DEPARTMENT OF PUBLIC WORKS

Request for a Modification to a Road Standard

Project Number:	PDS2015-STP-15-022	**Date of Request:**	October 19, 2017
Project Location:	Valley Center Road at Cole Grade Road, Valley Center, CA 92082		
Thos. Bros. Map/Grid:	1090/F-1	**APN:**	188-250-19
Requestor Name:	Gary Wynn, P.E.	**Telephone:**	760.749.8722
Address:	27315 Valley Center Road, Valley Center, CA 92082

NO CROSSING OVER CENTERLINE
CURB CUT EXHIBIT-1

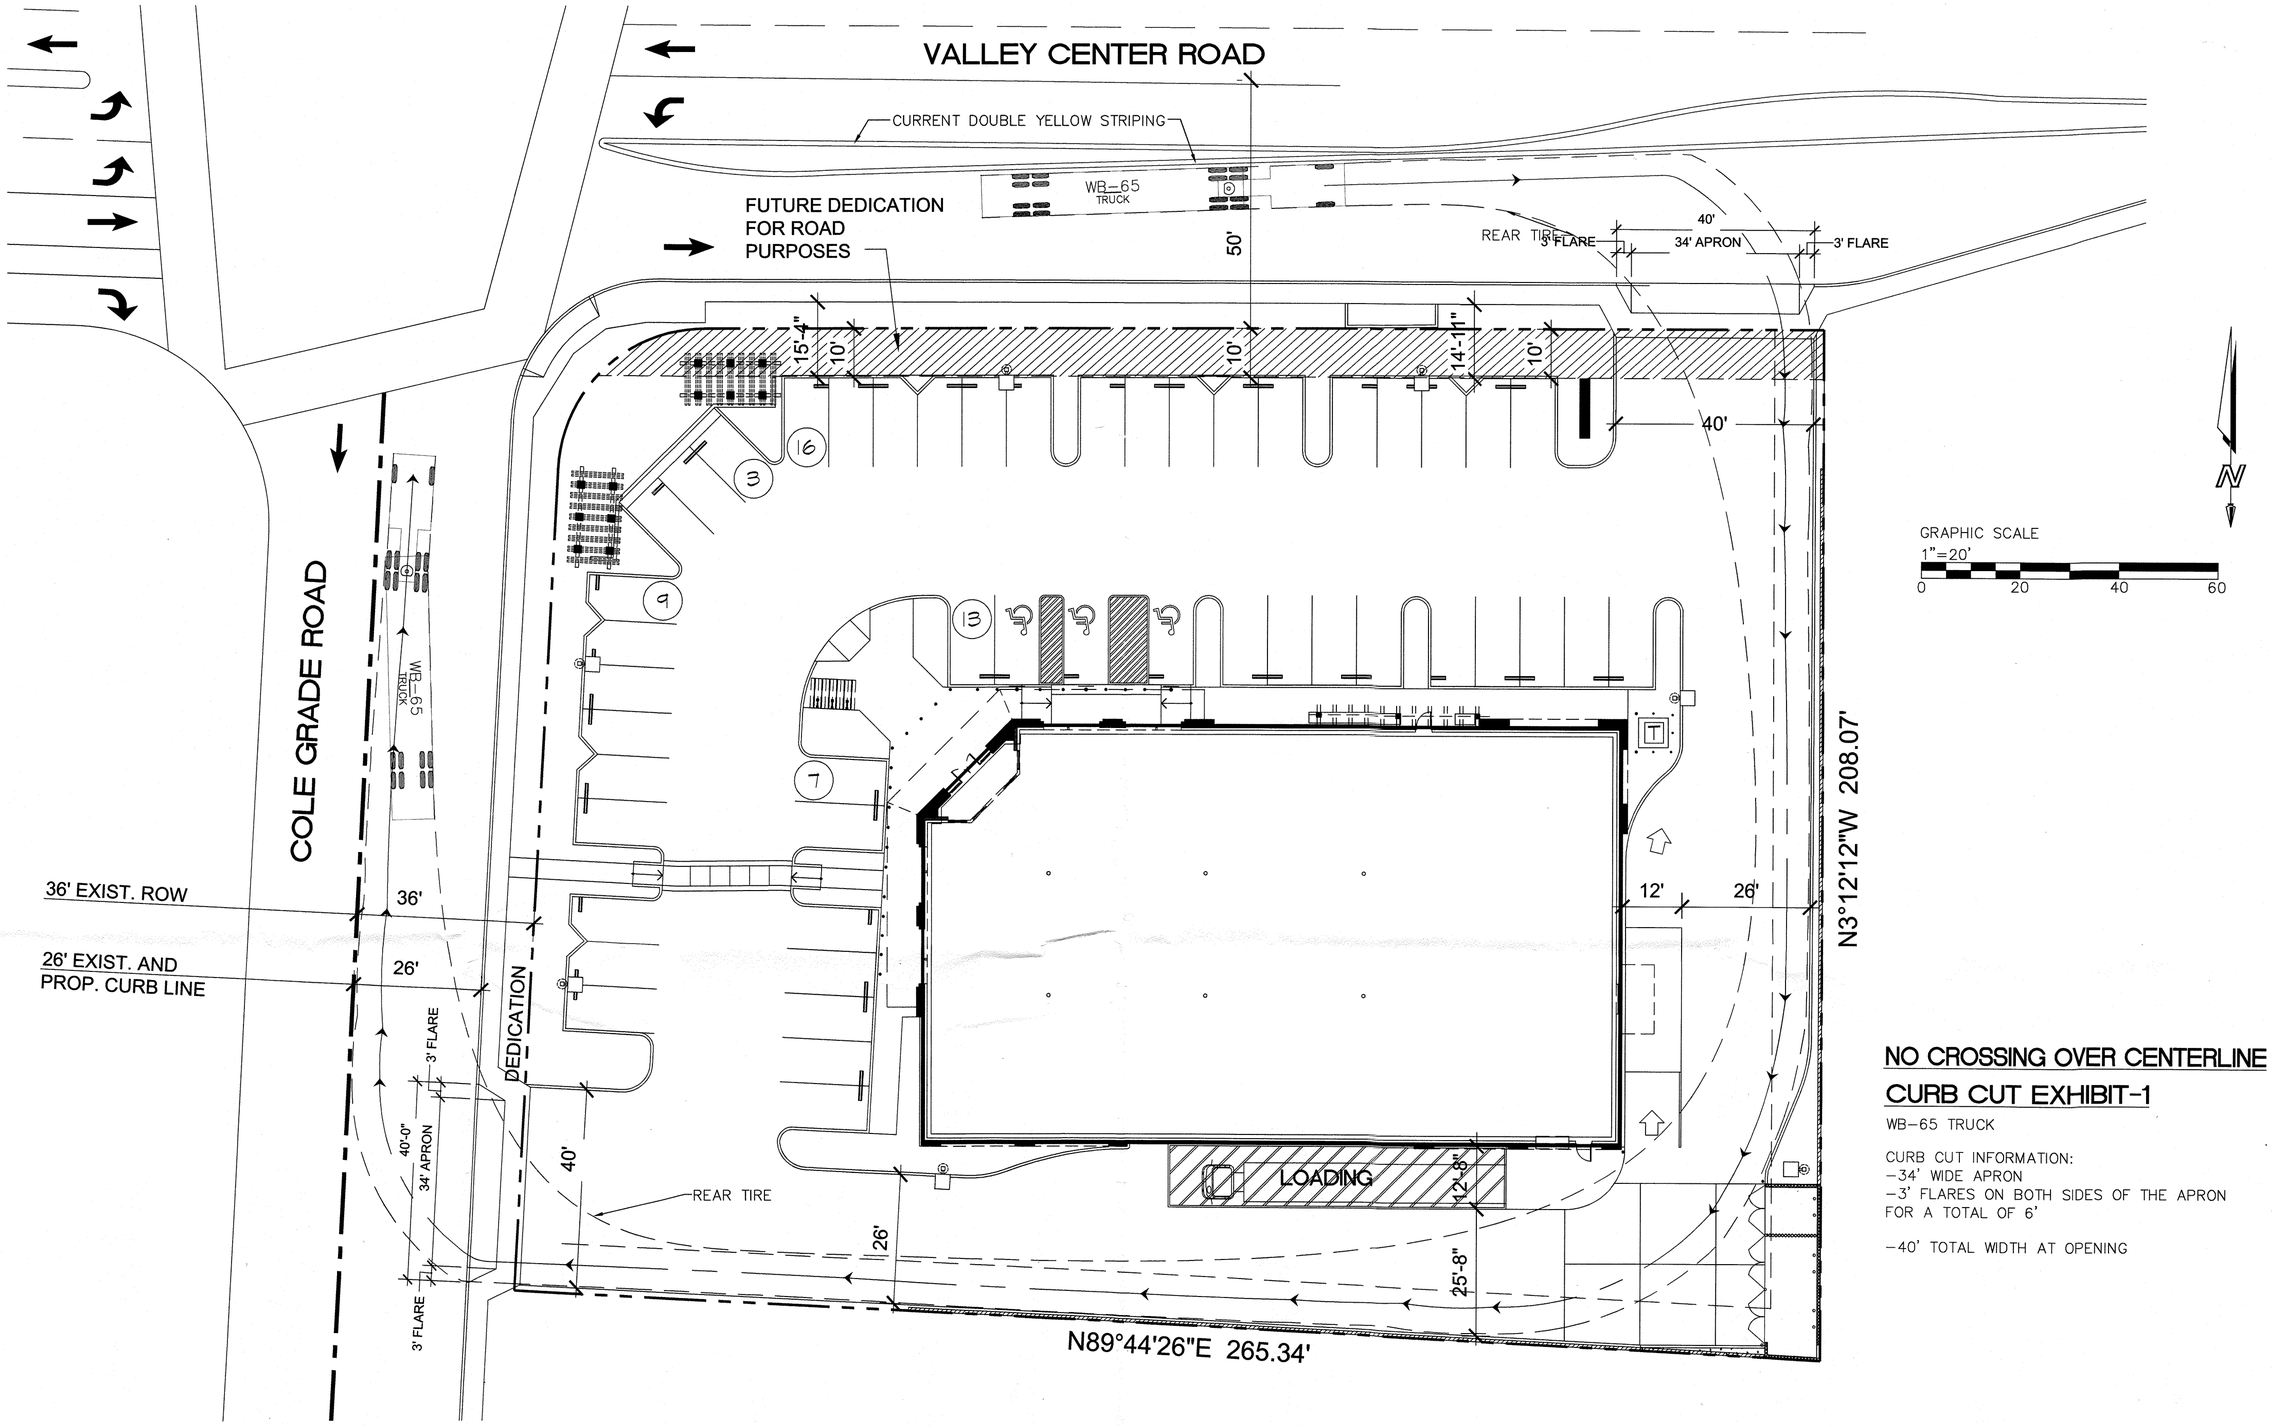
The request is to allow for new 40' driveway entries (34'+ 3' + 3' =40') for the proposed Rite Aid Store at both the Valley Center Road and Cole Grade Road future curb cuts. San Diego Regional Standard Drawing G-16 allows for a 30' maximum commercial driveway width with three foot flairs for a total maximum width of 36'.

Therefore, design of the driveway was modified from the standard 30' foot maximum width with tapers to a maximum 34' width plus tapers, (see attached site plan). This modified design therefore reduces the

potential for the trucks to jump the curb and reduces the potential for trucks to cross over the centerline (see attached truck turning templates for proposed site design).

CURB CUT INFORMATION:
-34' WIDE APRON
-3' FLARES ON BOTH SIDES OF THE APRON FOR A TOTAL OF 6'

-40' TOTAL WIDTH AT OPENING

CURB CUT EXHIBIT-3

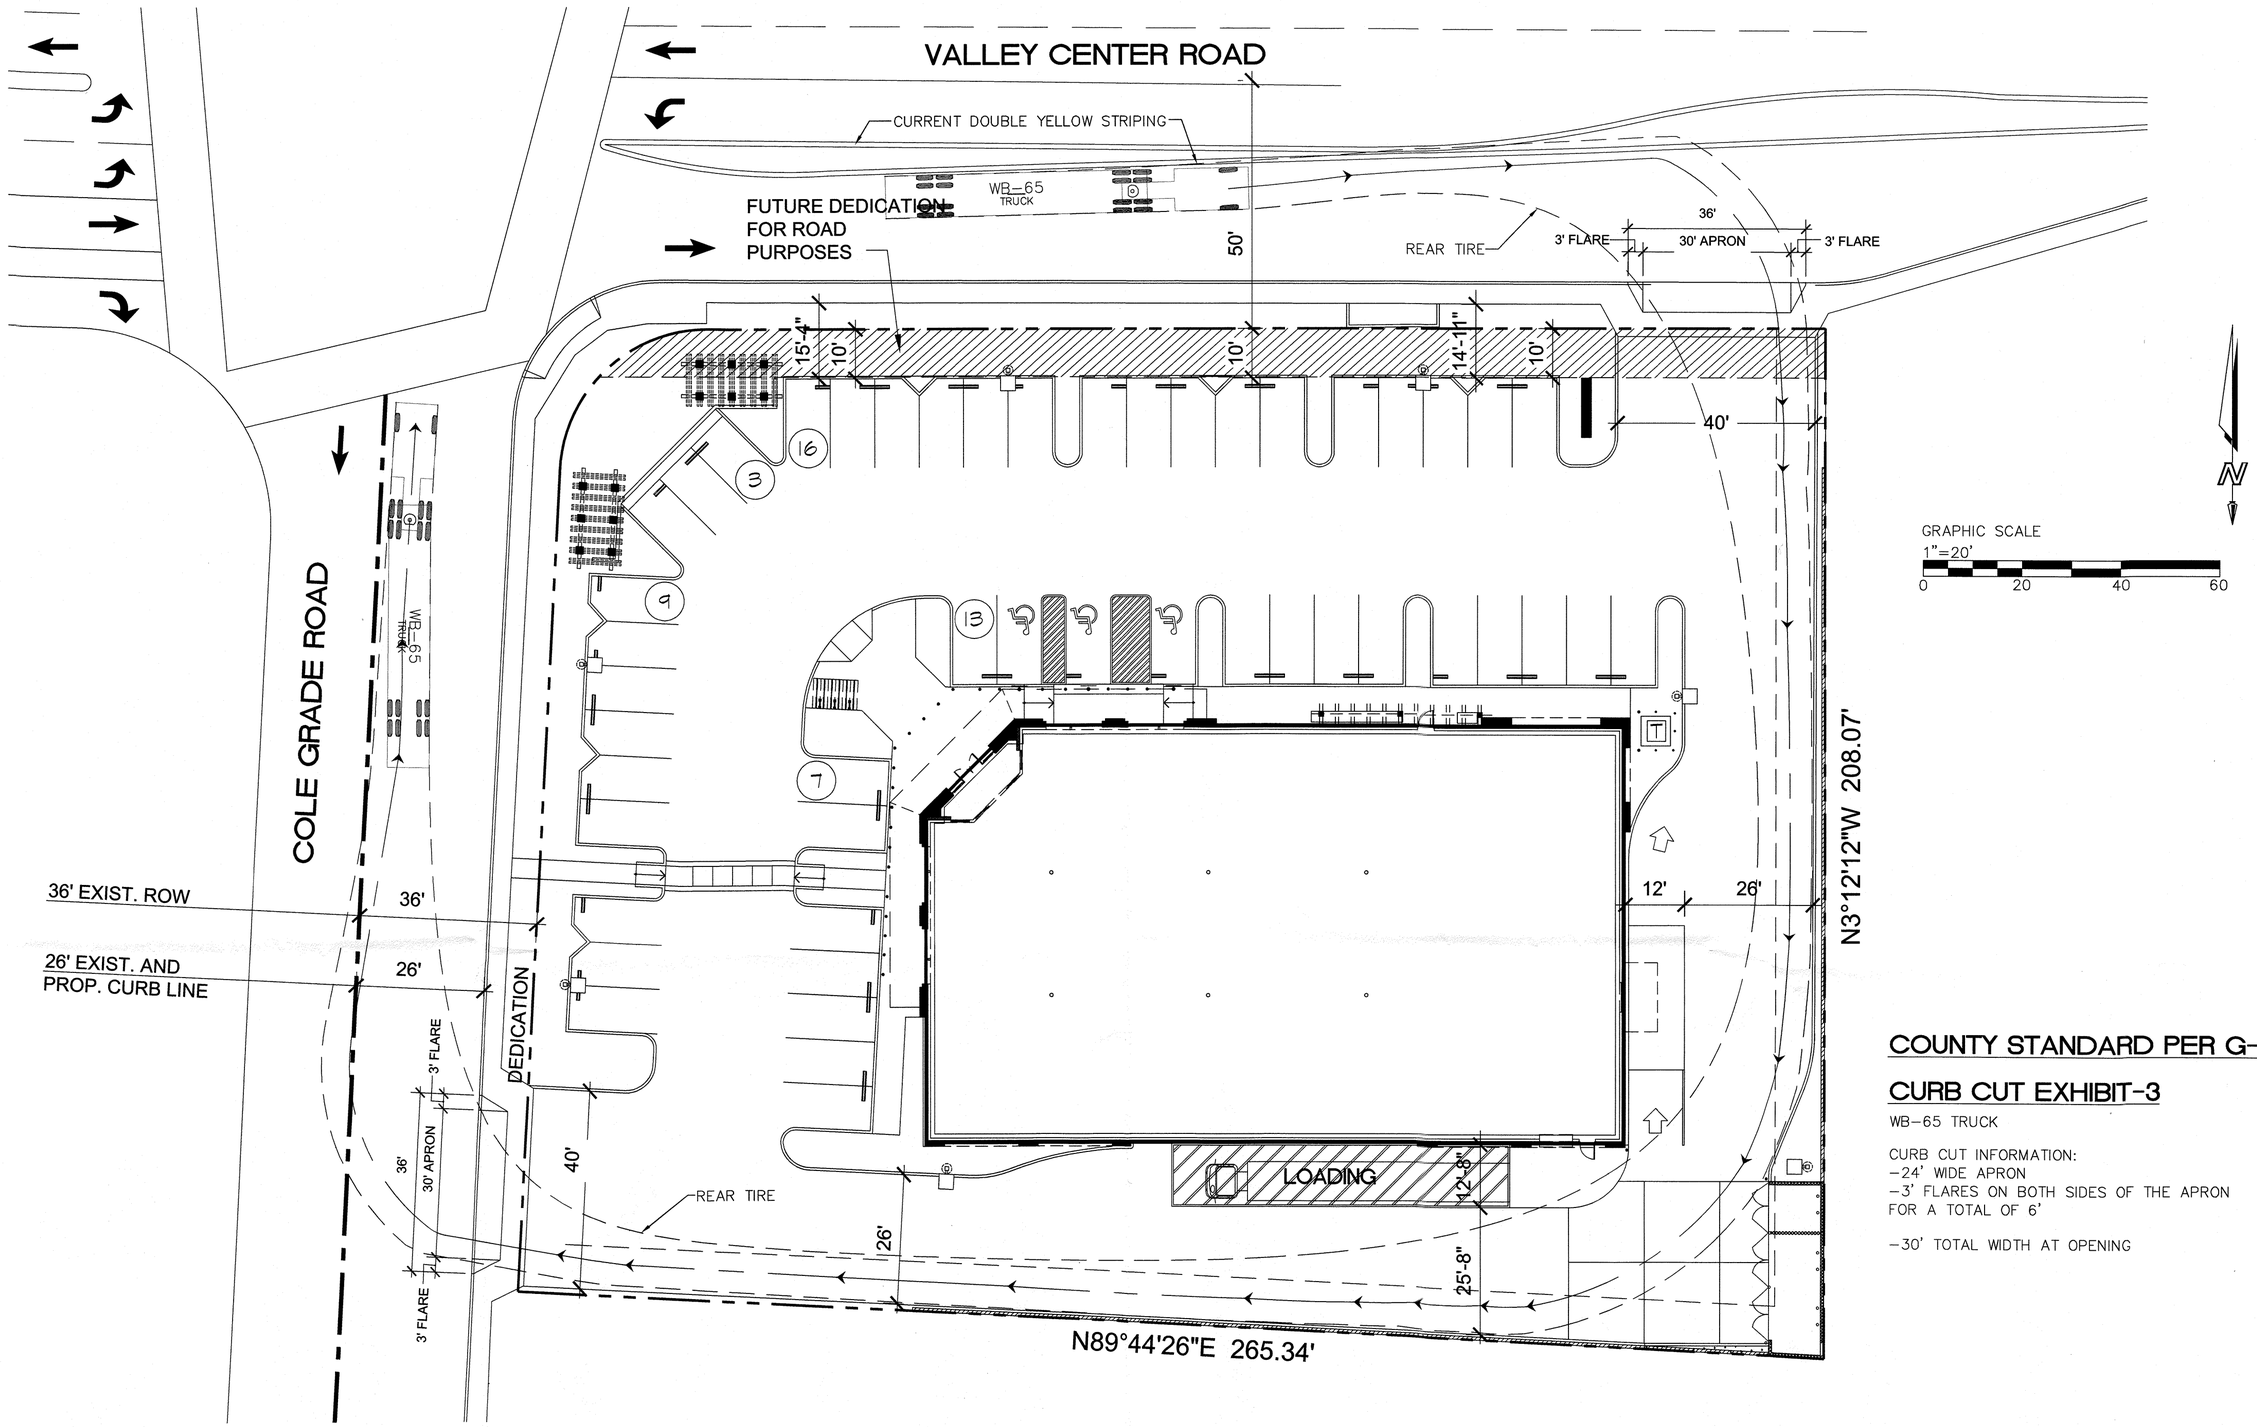
In meetings with County staff, concerns were raised regarding the potential for large delivery trucks to access the site with a standard driveway. Truck turning templates were therefore overlaid on the driveways to evaluate the truck turning paths. The results of this analysis determined the following:

- A WB-65 truck cannot make the turn into or out of a standard driveway without jumping the curb.
- A WB-65 truck cannot make the turn into or out of the standard driveway without crossing over the center line of the roadway

- Maintain the regional standard drawing and allow trucks to jump the curb or cross the centerline
